# PROJECT COMMENTS

PROJECT NUMBER: SP2026-012  
PROJECT NAME: Site Plan for 276 Business Park  
SITE ADDRESS/LOCATIONS: 1375 STATE HIGHWAY 276, ROCKWALL, TX 75032

04/23/2026: SP2026-012; Site Plan for 276 Business Park

SHEET CONTENT:  
**LANDSCAPE PLAN**

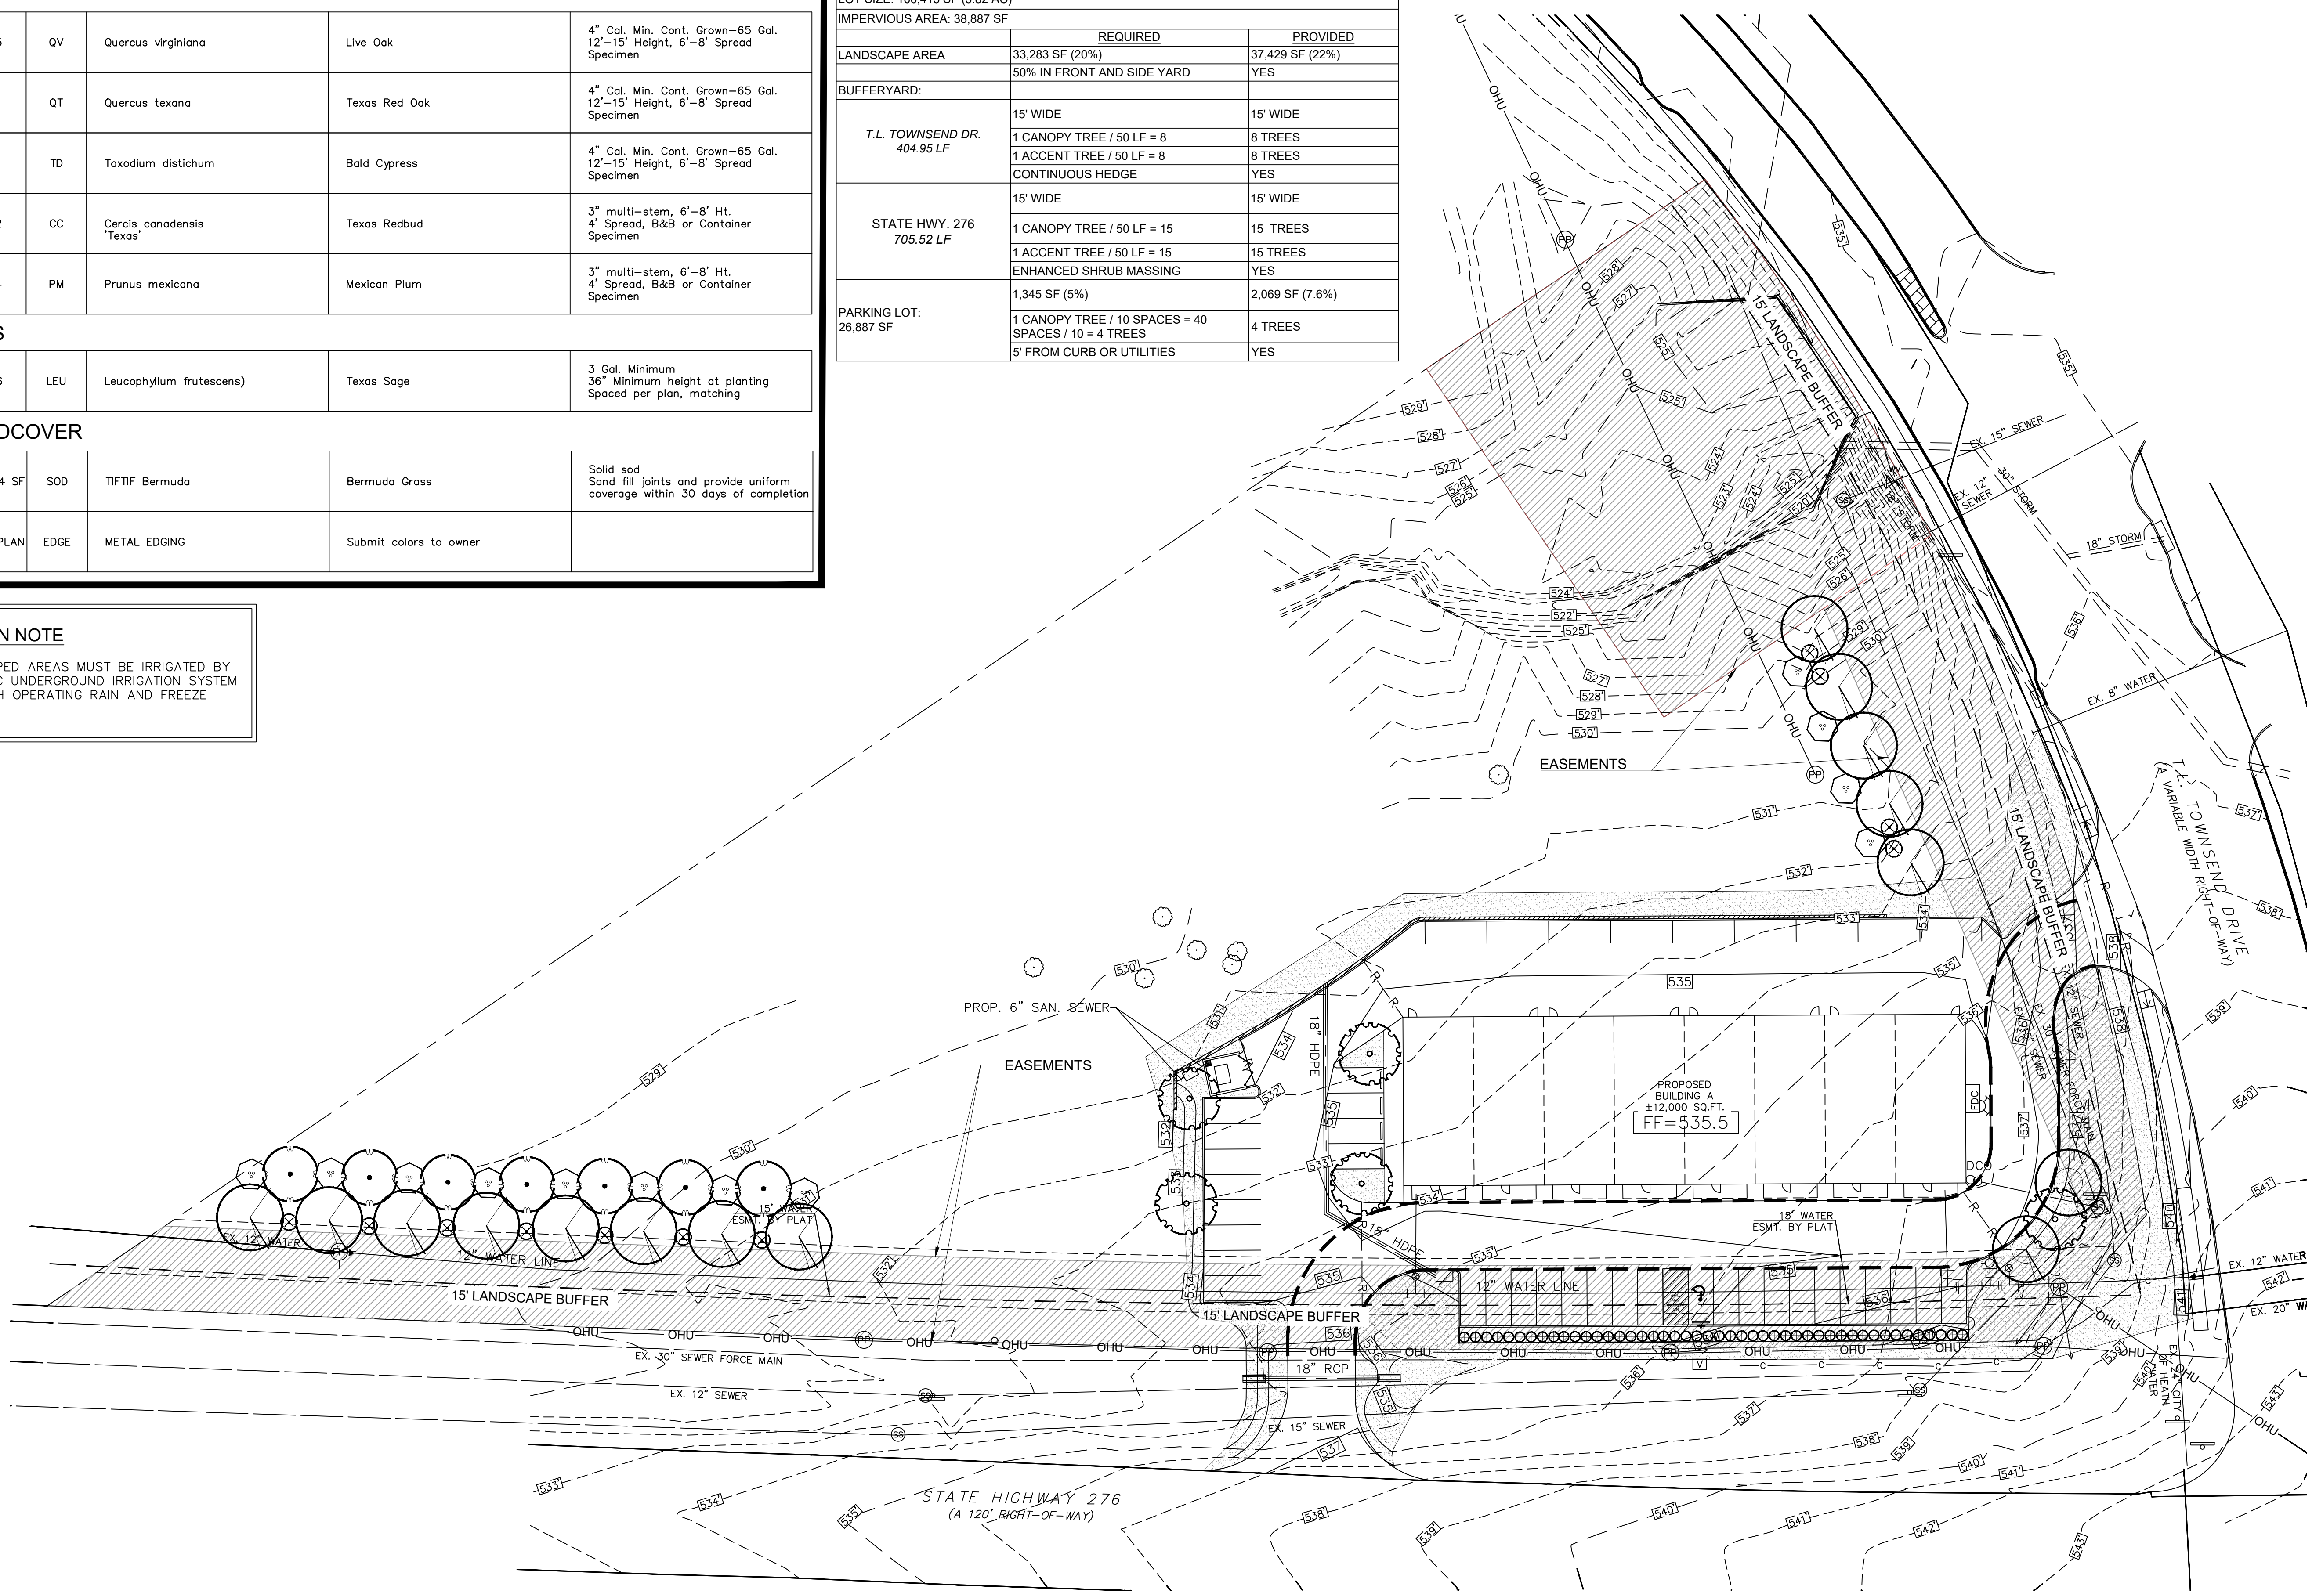
#### M.7 Landscape Plan

- 1) The Landscape buffer required along SH-276 and T.L. Townsend is 15-feet. Parking is not permitted in the Landscape Buffer and the landscape buffer must be outside the utility easements required along 276 and TL townsend. (Subsection 06.02.E, Article 05, UDC)

- 2) All landscape buffers shall incorporate ground cover, a built-up berm and shrubbery or a combination thereof along the entire length of the frontage. Berms and shrubbery shall each have a minimum height of 30-inches and a maximum height of 48- inches. In addition, two (2) canopy trees and four (4) accent trees shall be planted per 100-feet of linear frontage.

- 3) Abutting Residential. A minimum of a 20-foot wide landscape buffer shall be required along the entire length of any nonresidential lot that abuts a residentially zoned or used property. (Subsection 05.01 (B)2, Article 08, UDC)

- 4) Any non-residential or multi-family land use or parking area that has a side or rear contiguous to any residentially zoned or used property shall be screened with a masonry fence a minimum of six (6) feet in height with canopy trees planted on 20-foot centers. Any non-residential or multi-family land use or parking area that has a side or rear contiguous to any residentially zoned or used property shall be screened with a masonry fence a minimum of six (6) feet in height with canopy trees planted on 20-foot centers. As an alternative, the Planning and Zoning Commission may approve an alternative screening method that incorporates a wrought iron fence and three (3) tiered screening (i.e. [1] small to mid-sized shrubs, large shrubs or accent trees, and canopy trees or [2] evergreen trees and canopy trees) along the entire length of the adjacency. The canopy trees shall be placed on 20-foot centers. (Subsection 05.02(B), Article 08, UDC)

- 5) All shrubs shall be a minimum of five (5) gallon in size. (Subsection 06.02(E)2, Article 05, UDC) Revise landscape table.
- 6) All parking spaces shall be within 80 feet of a canopy tree (Subsection 05.03(E), Article 08, UDC)

- 7) Identify visibility triangles for all driveway intersections and public streets. (Subsection 01.08, Article 05, UDC)
- 8) Provide a note indicating that irrigation will meet the requirements of the UDC. (Subsection 05.04, of Article 08, UDC)

- 9) Dumpster enclosures require to be screened by 5-gallon evergreen shrubs. (Subsection 01.05(B), Article 05, UDC)
- 10) If there is any pad-mounted utility equipment, it will need to be screened by 5-gallon evergreen shrubs. (Subsection 01.05(C), of Article 05, UDC)

- 11) Detention basins shall be landscaped in a natural manner using ground cover, grasses, shrubs, berms, and accent and canopy trees. There shall be a minimum of one (1) Canopy Tree per 750 SF and one (1) Accent Tree per 1,500 SF of detention area. (Subsection 05.03(D), Article 08, UDC)

04/20/2026: Tree mitigation required  
 Landscape buffer cannot be in utility easement  
 All parking spaces must be within 80' of a tree canopy  
 Identify detention pond landscaping and trees

1 ELECTRICAL PHOTOMETRICS PLAN

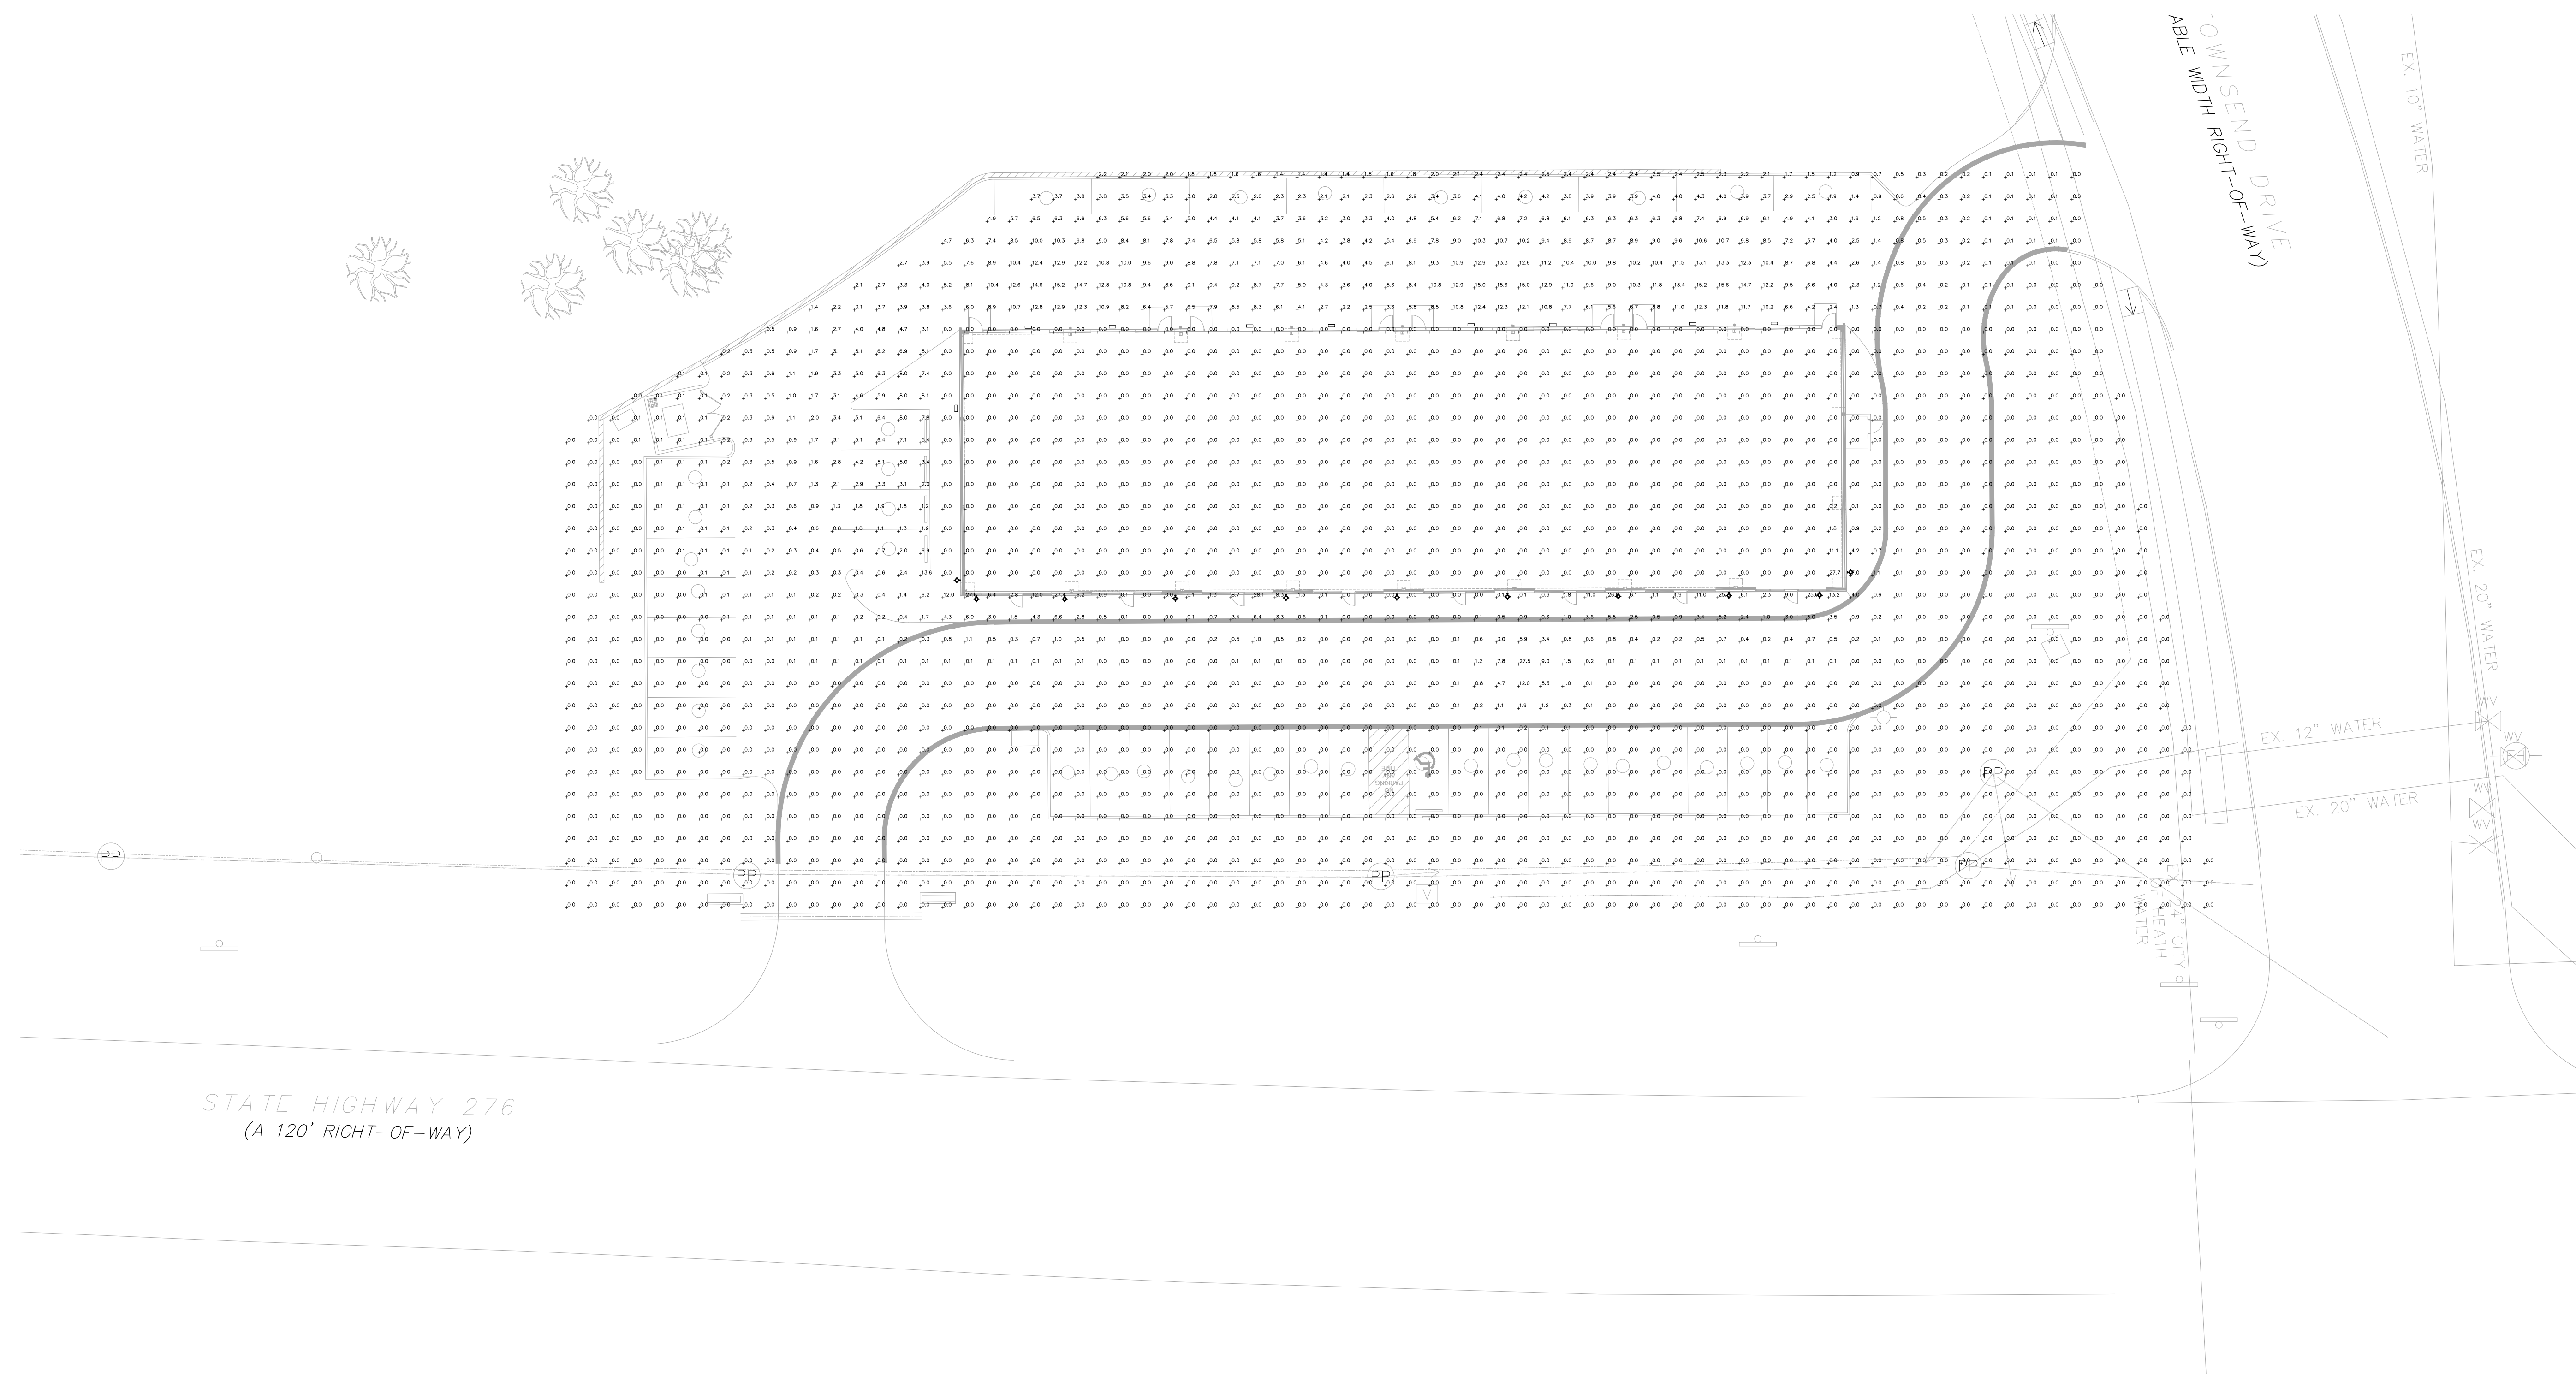
M.9 Photometric Plan

- 1) The allowable maximum light intensity measured at the property line of a non-residential property is 0.2 FC of one footcandle. (Subsection 03.03.C, of Article 07, UDC) Provide the FC readings at the northern property line.

- 2) Under canopy lighting shall not exceed 35 FC. (Subsection 03.03.E.1, of Article 07, UDC)
- 3) The maximum outdoor maintained computed and measured illumination level within any nonresidential development shall not exceed 20 FC outdoors at any point on the site with the exception of the under-canopy lighting as mentioned earlier. (Subsection 03.03.G, Article 07, UDC)

- 4) The maximum mounting height for lighting shall be 20 feet in the SH-276 Overlay District (Subsection 06.02.G, Article 05, UDC) Please indicate mounting height for all lighting.

- 5) Any unshielded light sources shall have a maximum wattage of 15 W. (Subsection 03.03.A, of Article 07, UDC)
- 6) Provide lighting cutsheets for all proposed light fixtures. (Subsection 03.03, Article 07, UDC)
